Staff Report: Magnolia Heights Preliminary Subdivision File No. PLZ-18-0055

Hearing Date	October 15, 2018 beginning at 6:30 PM
Proposal	Subdivide one (1) legal lot of record, PIN 120967-000, approximately 2.98 acres in size, into a total of eleven (11) building lots for single-family detached homes. An existing single-family home will remain on one of the new building lots leaving ten lots available for new homes. The project is zoned RLD-6. The Magnolia Heights Subdivision is located west of the recently approved Union Ridge Ranch Preliminary PUD Subdivision (PLZ-17-0074), south of the “Bellwood Heights Phase 1” Subdivision, west of N. 20 th Place.
Project Location	1956 N 3rd Way, Ridgefield, WA 98642. PIN: 120967000. The project is located within a portion of the NE ¼ of Section 19, T4N, R1E
Property Owner	Ian and Brenda Borgstedt, 1956 N 3 rd Way, Ridgefield, WA 98642.
Applicant / Applicant’s Representative	Sterling Design, Inc., 2208 E Evergreen Blvd / Vancouver, WA 98661 Contact: Joel Stirling, 360.759.1794, joel@sterlingdesign.biz

FIGURE 1. MAGNOLIA HEIGHTS SUBDIVISION PRELIMINARY PLAT

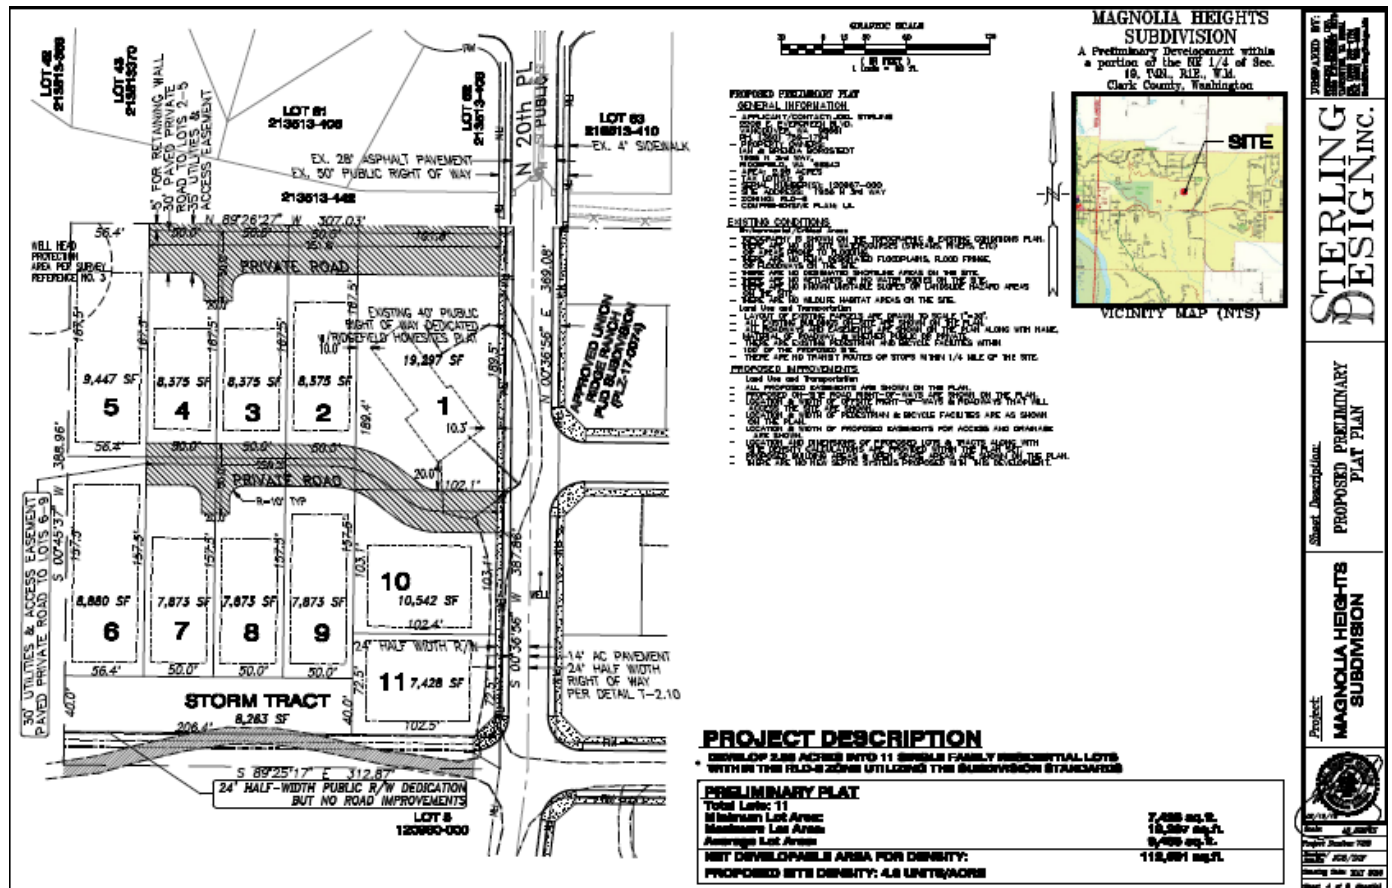
The proposed development includes half width frontage improvements on N 20th Place. No improvements are proposed for N 3rd Way. The project narrative requests a design modification allowing improvements to N 3rd Way be limited to ROW dedication only, with financial assurance for the improvements to be completed with development of the adjacent properties.

The project also proposes two private streets, each serving four lots. Proposed private streets are 251.6 and 257 feet in length, respectively. The narrative requests a design modification to allow the two private streets with the modified hammerhead turnarounds.

The narrative also requested a design modification to allow the central private street centerline to be offset from the centerline of N 4th Way in the recently approved Union Ridge Ranch subdivision.

All streets internal to the project are proposed to be private streets and do not extend to the limits of the property.

Staff finds that the design modifications requesting no improvements be constructed for N 3rd Way and requesting two private roads be constructed within the development using modified hammerhead turnarounds do not meet the approval criteria. As a **condition of approval**, the development shall stub one public street, either N 3rd Way or the southernmost private street, to the western property boundary of the proposed project. As a **condition of approval**, the road stubbed to the western boundary shall be constructed to comply with the City's Local 'A' cross section. As a **condition of approval**, all turnarounds must meet the requirements of Section 2.13 of the engineering standards.

To be consistent with the identified Comprehensive Plan policies, **staff finds** that the proposed site plan should provide additional future street connections (stubs) to potentially developable land adjacent to the site and easements as necessary. **Staff finds** that based on the number of new single family lots, the project will generate less than 10 p.m. peak hour trips and a traffic impact analysis is not required.

Staff finds that the requested design modification to alter the alignment of the central private road so that the center line does not align with N 4th Way in the recently approved Union Ridge Ranch subdivision meets approval criteria number 3 because alignment would require removal of the existing home resulting in an undue hardship.

FIGURE 3C. 1995 SURVEY SHOWING DRAIN FIELD EASEMENTS

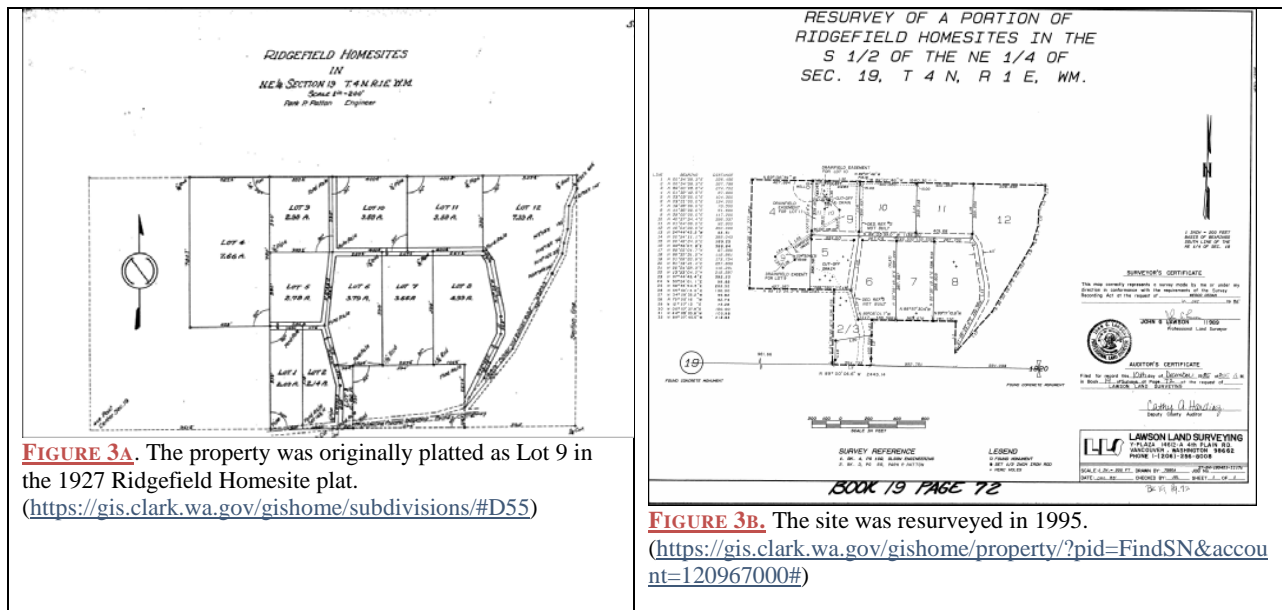
The District provides sewer service to the site. The development is required to use all reasonable means to provide gravity service to all lots. The current point of connection is located in NE 19th Court. An existing easement (CC 5363374) is recorded from SN 213492-000 for the sanitary sewer extension and is currently under construction as part of the Union Ridge Ranch project. The plans will be required to use a survey datum provided in NGVD 29(47). Any on-site septic systems discovered during construction will be abandoned per Clark County Health Code.
